DATE: July 8, 2022

SUBJECT: PRODUCT CHANGE NOTIFICATION – 100-600Amp, Class J&T Fuse Holders

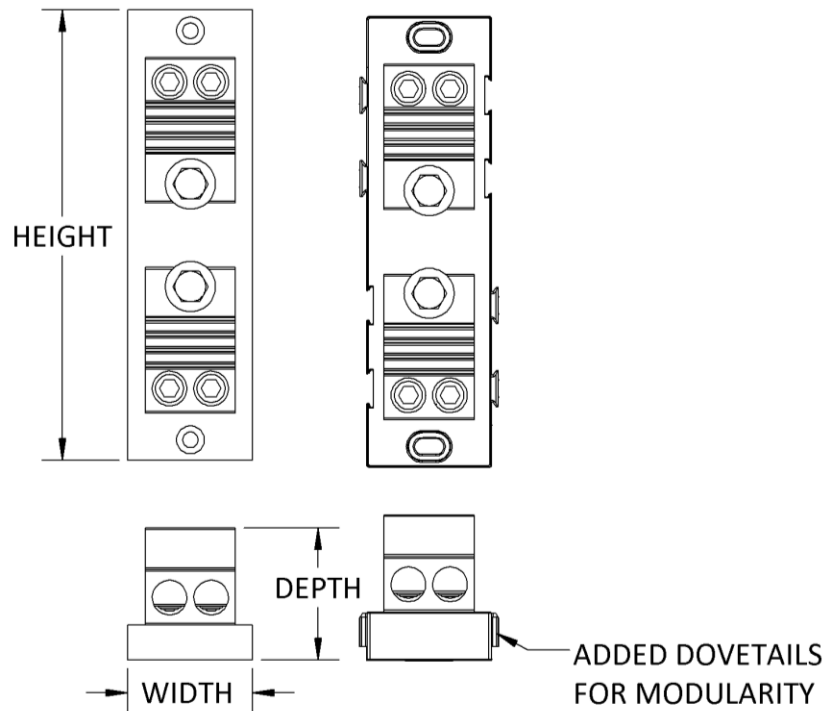
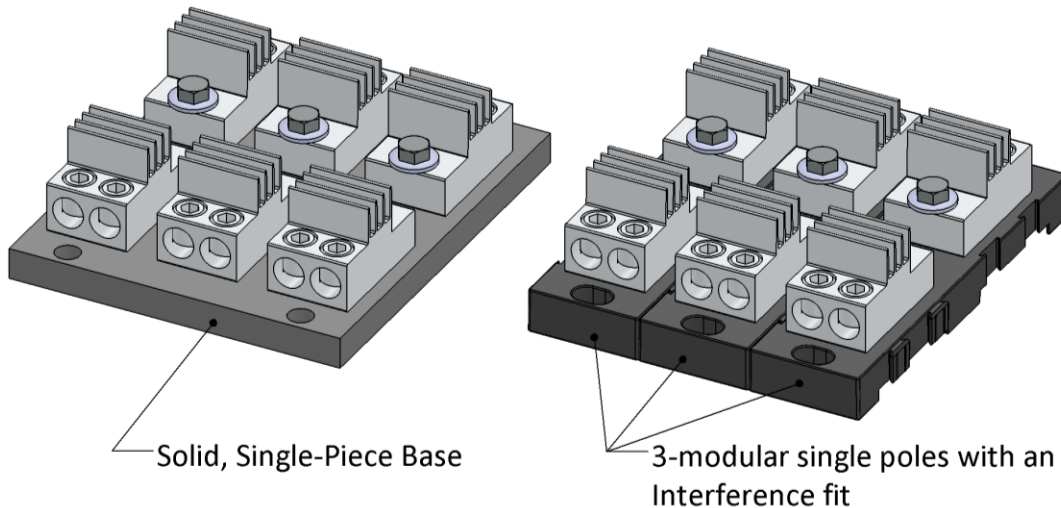
Marathon Special Products is announcing a minor change to our **100-600Amp, Class J&T Fuse Holders**. This product change is due to new tooling needed to maintain the product line, manufacture it more efficiently, as well as utilize a sustainable/recyclable material for the insulator base. This will be a running change that has no effect on part numbers or agency certification. These changes will only affect the part numbers noted below. The changes are as follows:

Old Version	New Version
Insulator Material	Laminated General Purpose Phenolic	Thermoplastic, Glass filled Polycarbonate
Insulator RTI Rating	130°C	125°C
Insulator Surface Finish	Dull top/bottom, rough cut side edges	Flat/matte
Recyclable/Sustainable Materials	No	Yes
Weight	Baseline existing models	23% reduction (average)
Modularity (ability to snap together single poles)	No	Yes
3-Pole Construction (where applicable)	Single Piece	Modular, Interference fit of 3-single poles
Depth (for all models)	Baseline existing models	.27" increase +/- .06
Width (for all models)	Baseline existing models	.11" increase +/- .06
Height	Same	
Mounting Locations	Same	
Other Component Materials	Same	
Catalog Numbers	Same	
UL File Numbers	Same
